NORTHEAST UTILITIES

Millstone Nuclear Power Station, Unit No. 3
Meeting Summary of NRC Structural Audit
Transmittal of Responses to Confirmatory Items

STATUS OF STRUCTURAL AUDIT DISCUSSION ITEMS
INCLUDING DSER OPEN ITEMS
AND 220 SERIES QUESTIONS

13-FIG #1

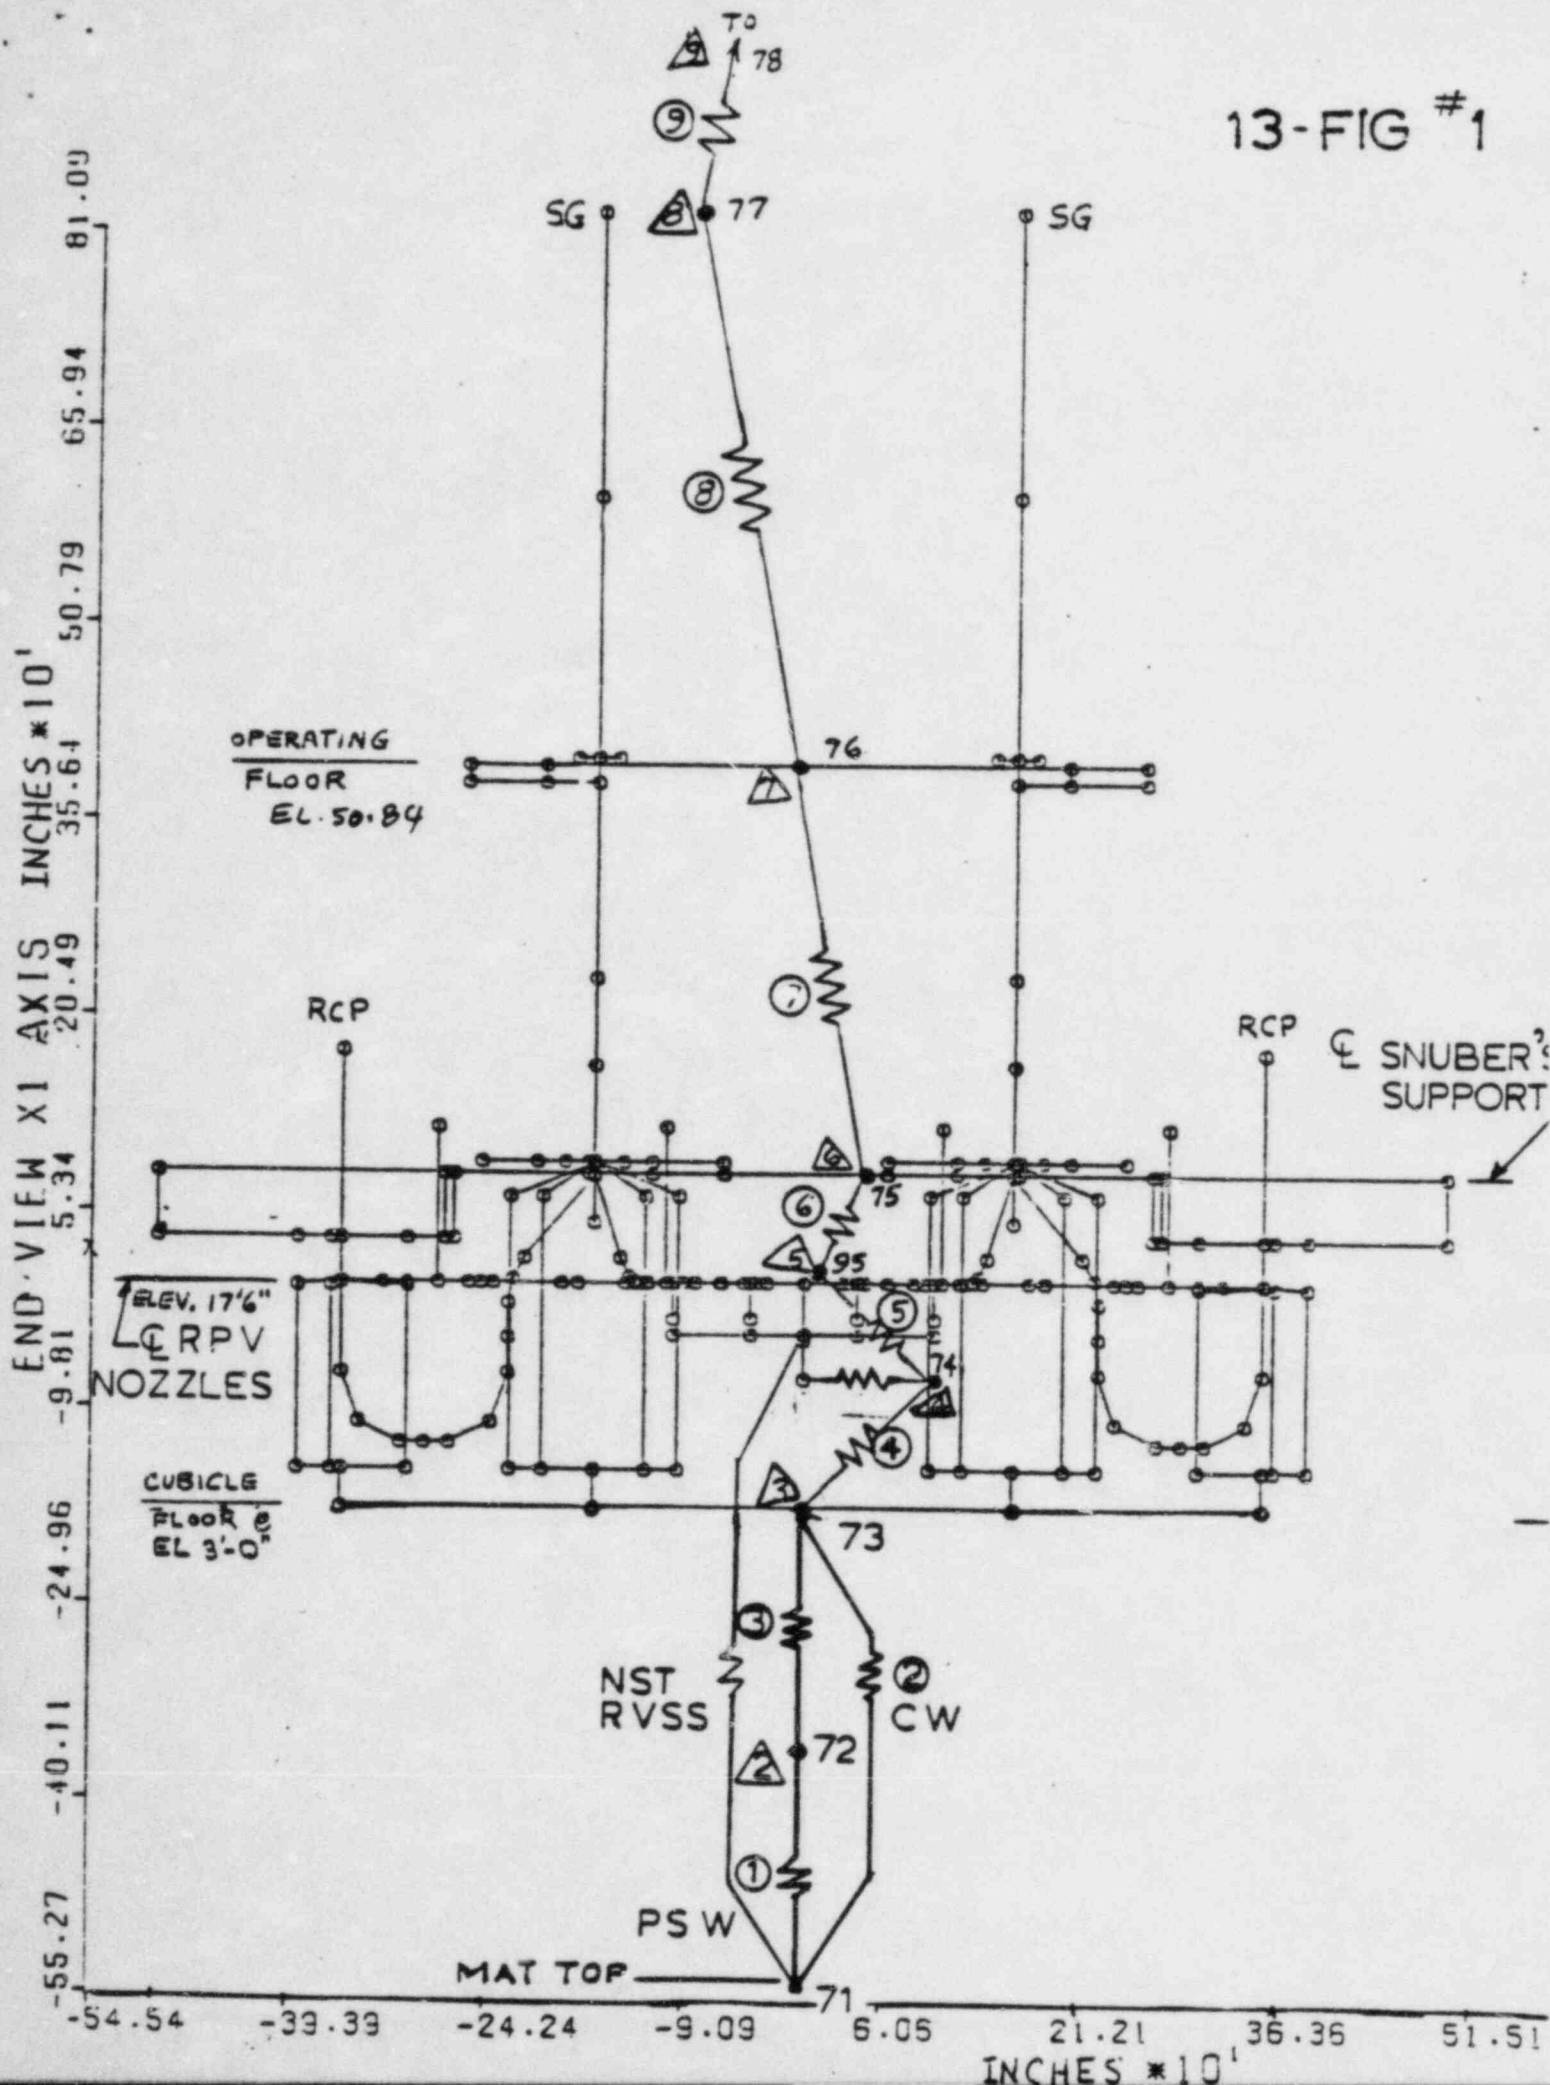
Item 13	Indicate how the effect of the NSSS systems were accounted for in the seismic evaluation, of internal structures.	Confirmatory
Item 14	Provide a detailed discussion on how the CM and CR are considered in development of stiffness matrix.	Confirmatory

The internal structure seismic model (Figure 3.7B-9, Building Model) is combined with the 4-loop reactor coolant system (RCS) model as shown in the attached Figure 1. In this model, the numbers in circles and triangles represent the building stick model springs and mass points. Node Numbers 73, 74, 75, and 76 represent the RCS model's connectivity to building model mass points.

The seismic response of the combined model was obtained using input motion histories (6 degree of freedom) at top of the containment mat (Node 71) obtained from output of the building model seismic analysis with rock springs and ground motion history (.17 g).

In both models, the common spring is No. 1 and represents primary shield wall (psw), instrumentation tunnel, and the portion of crane wall. This member represents a major structural element which transfers seismic forces into the mat and has been selected to compare the forces (at bottom support) as evaluated both from the building model and the RCS combined model.

Table 1 shows the results are comparable and the model used in the seismic analysis of the structure adequately predicts the structural response to seismic motion.

FIG 1

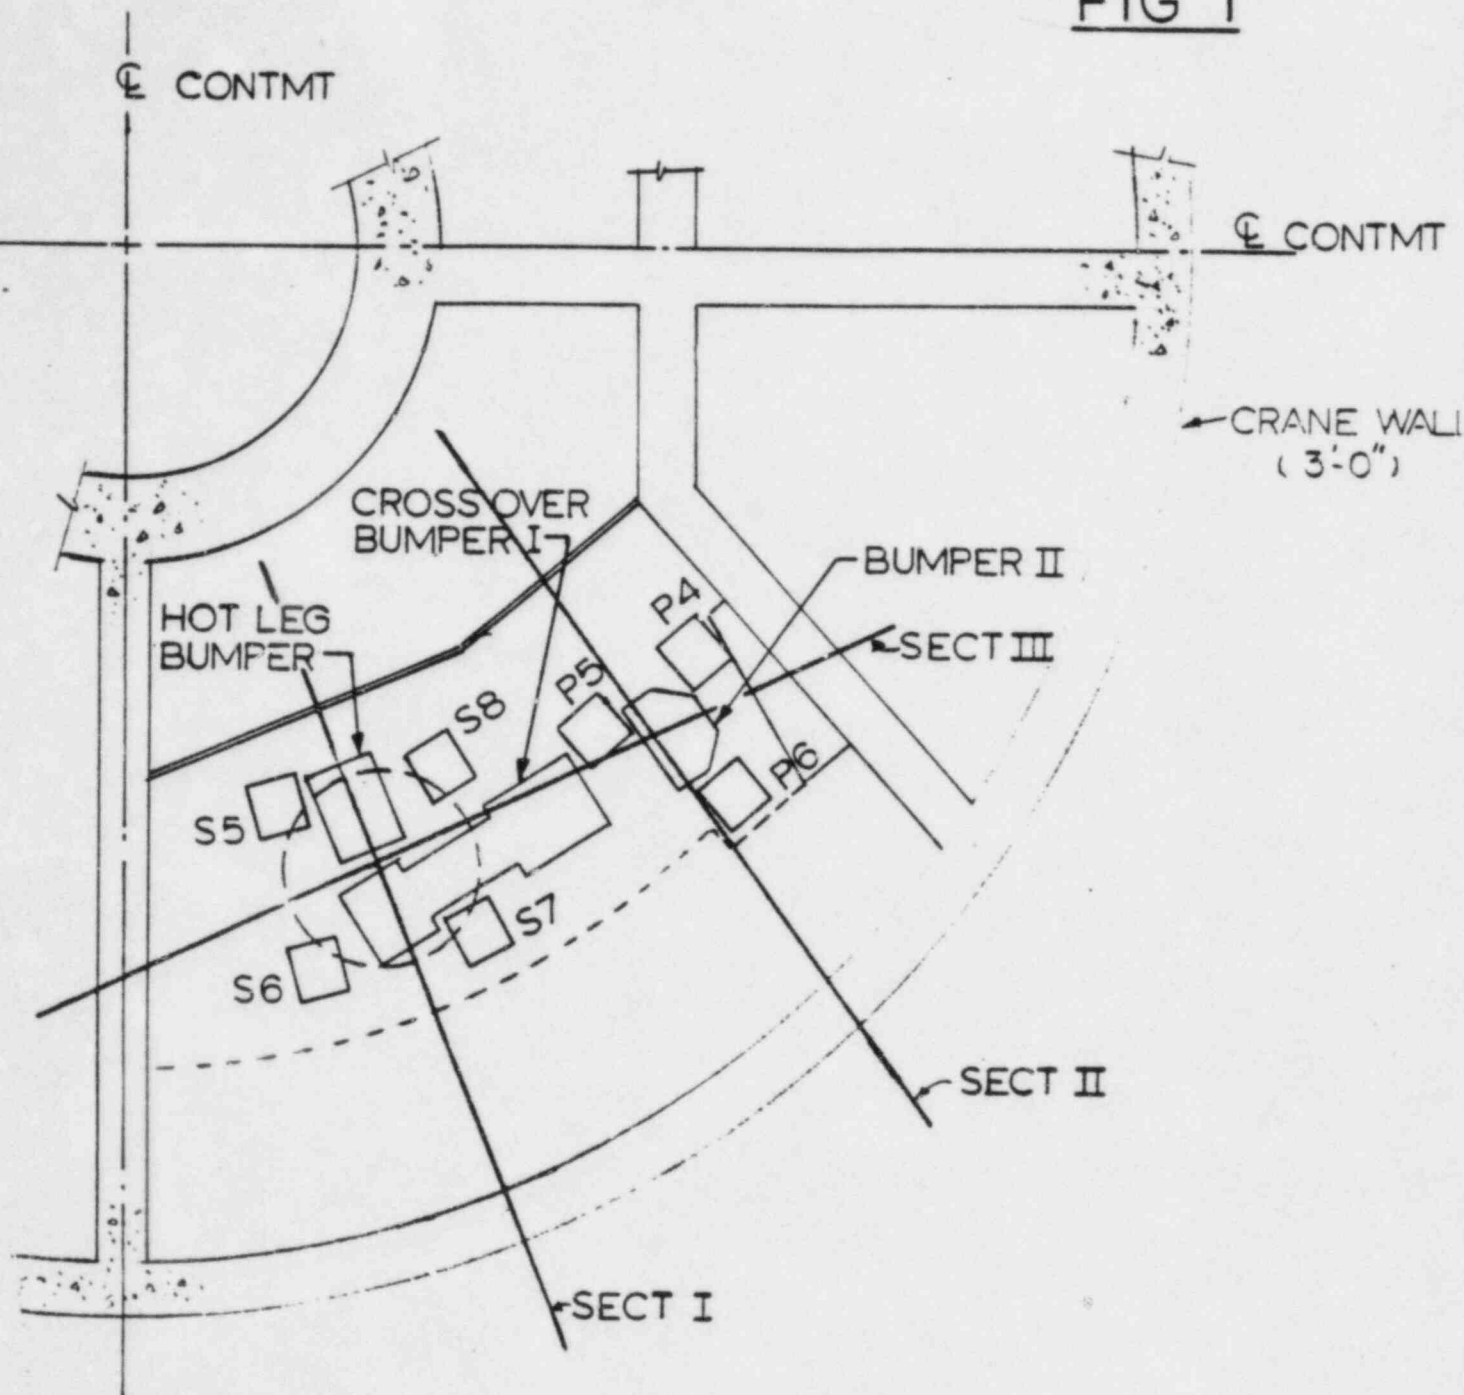
ITEM 19 Provide a comparison of results in internal structure from Finite Element analysis and STRUDL. An example of the results of comparison was presented and the item was resolved. The Applicant will provide sketches and documentation.

Figure 1 shows the plan view of cubicle "B" at el 3 ft-8 in. Steam generator supports S_5 , S_6 , S_7 , S_8 , and RC pump supports P_4 , P_5 , and P_6 are shown in relation to hot leg bumper, cross over bumpers I and II, and steam generator column below el 3 ft-8 in. slab. For the frame analysis of slab at el 3 ft-8 in., walls of the cubicle and the slab is divided into frame sections. Frame sections I, II, and III have been selected and are shown on Figure 1. For stiffness analysis of the frame, STRUDL II computer program is used.

EAST WALL STRESSES - LOADING 3 (HYDROSTATIC LOAD)

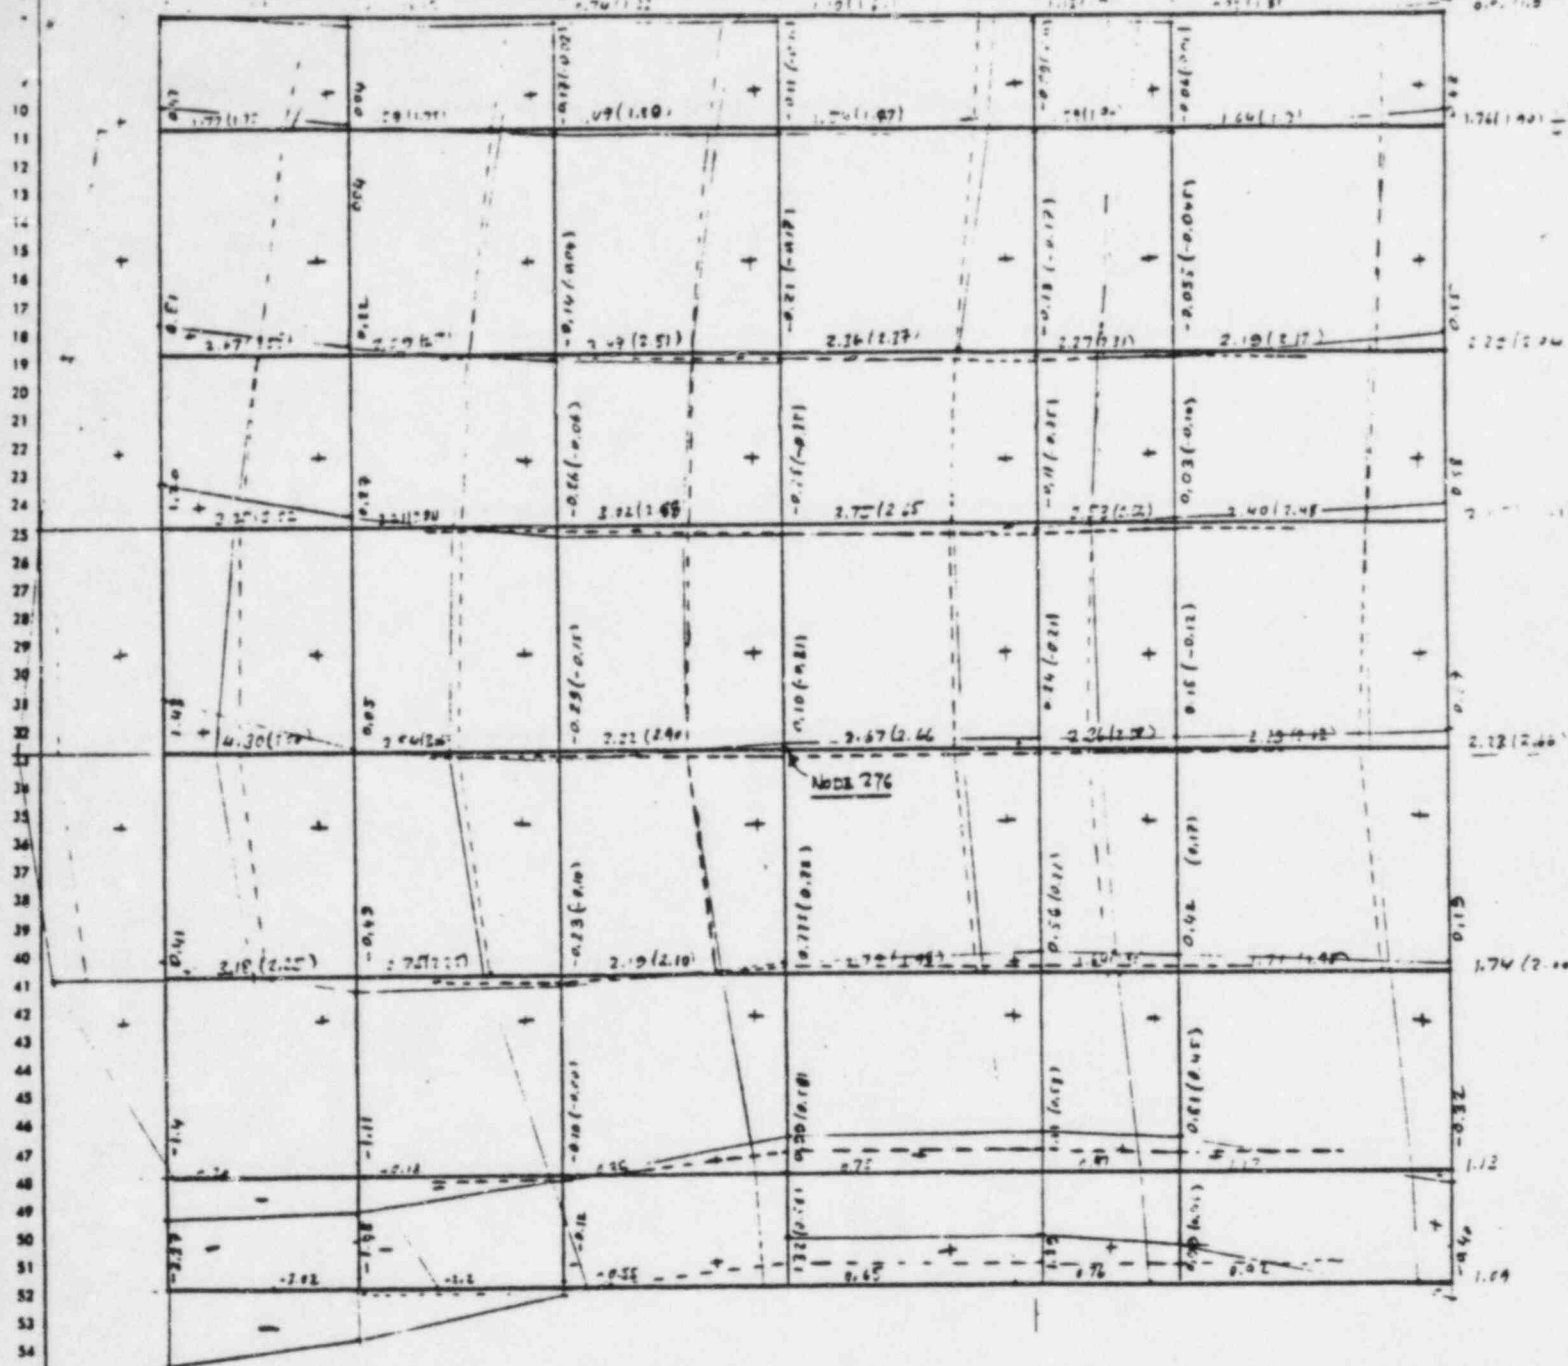
ITEM 29 Provide the Finite Element-Frame Analysis comparisons for the Spent Fuel Pool Analysis. An example of the results of comparison was presented and the issue was resolved. The Applicant will provide the documentation.

Fig 3-1

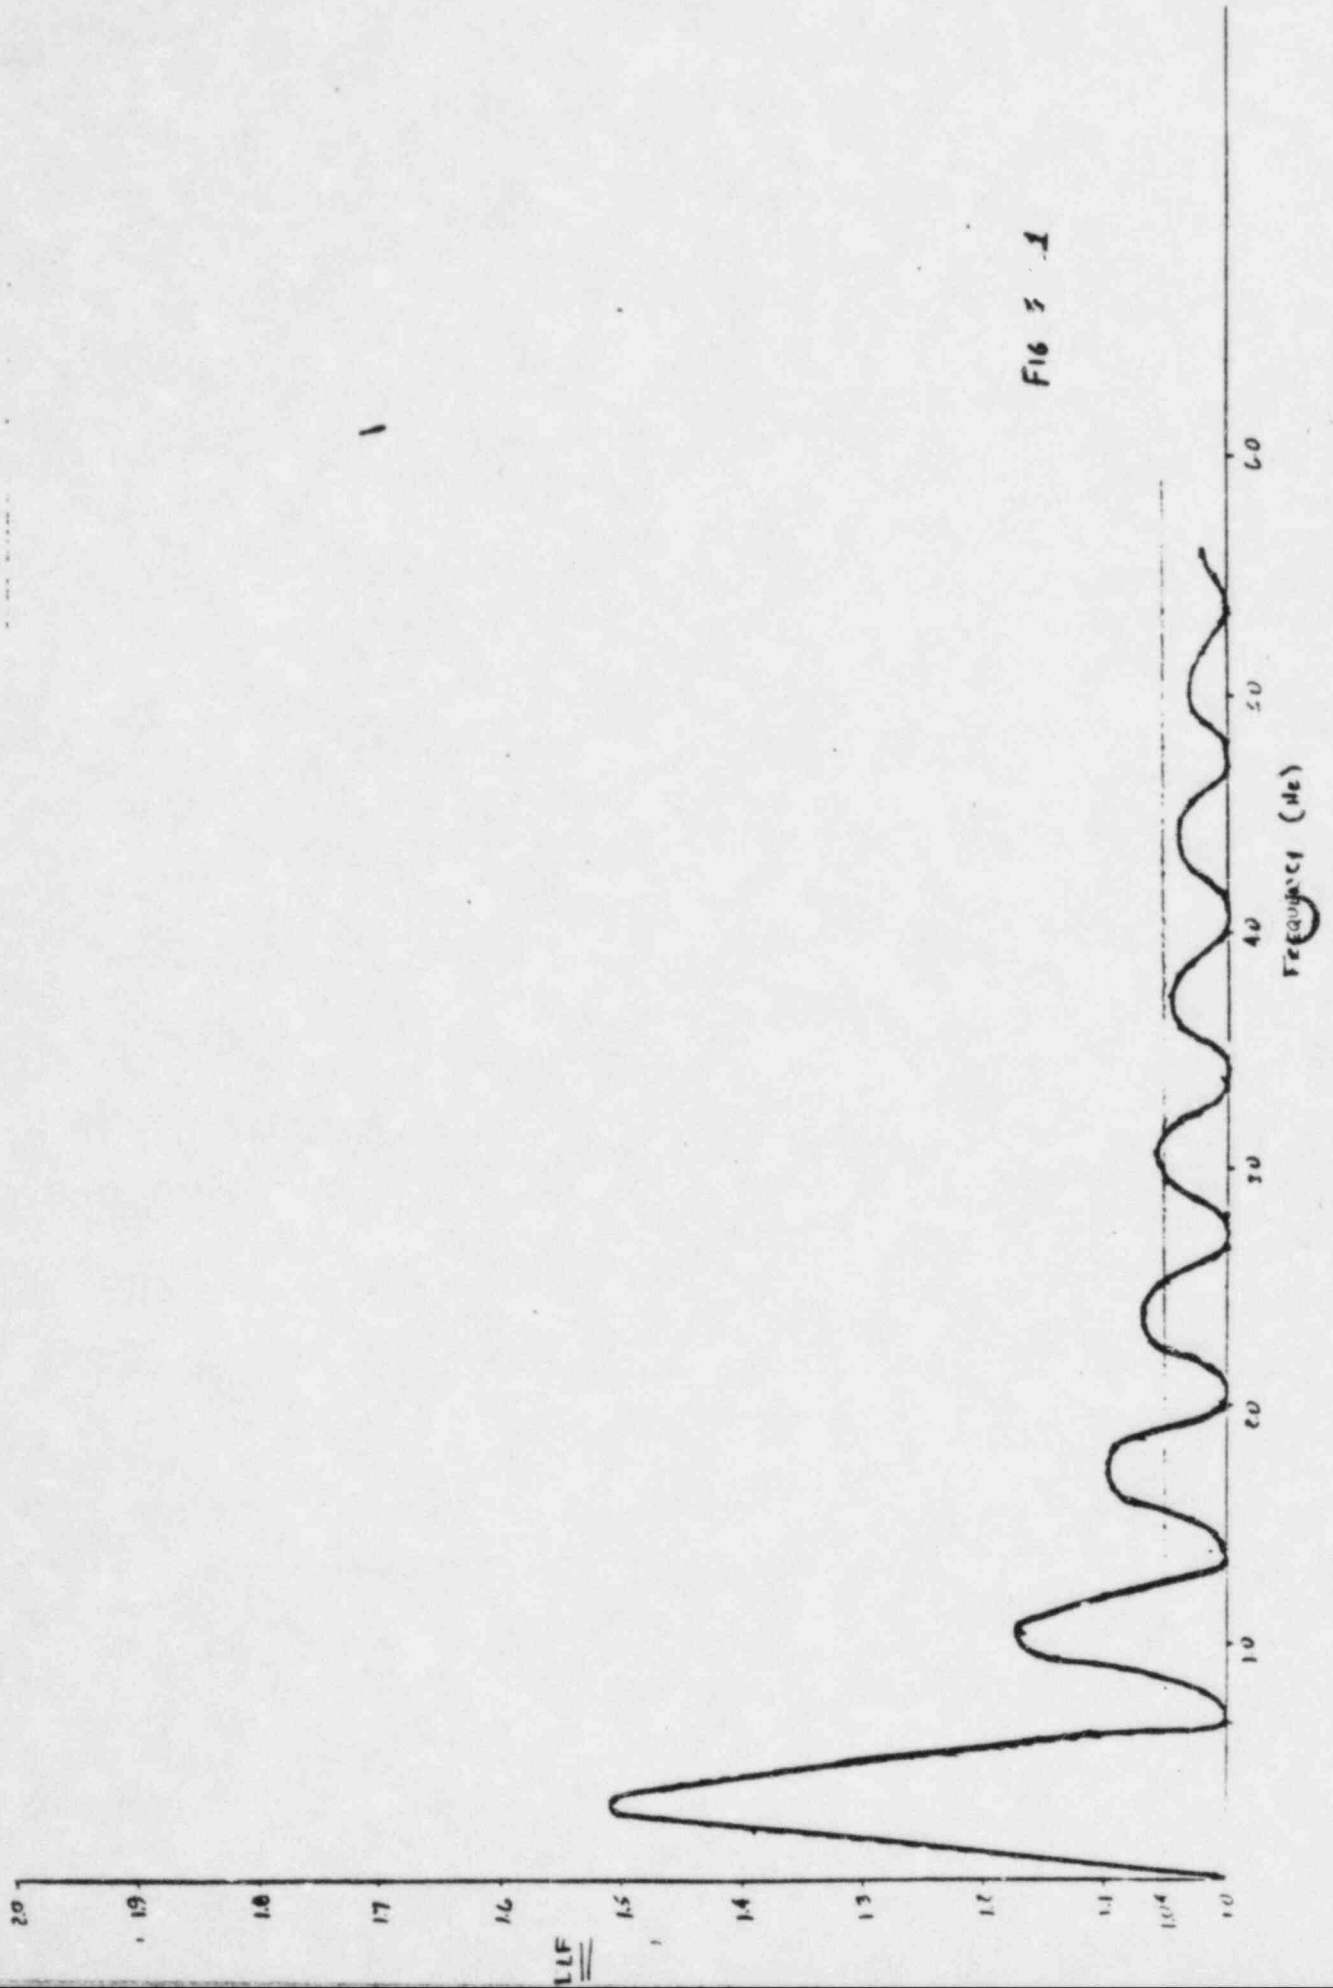
ITEM 33 Justification of unity DLF of pressure drop provided description and results as presented. Resolved. The Applicant will provide the response.

A dynamic load factor of 1.0 is applied to the pressure drop since all wall and floor panels subject to pressure drop have frequencies greater than 4 Hz as shown in Table 3.3.1. Figure 3.3.1 presents the calculated dynamic load factor curve for the pressure drop. Comparing the two it is evident that the Millstone III structural elements experience no dynamic amplification during the pressure drop condition.
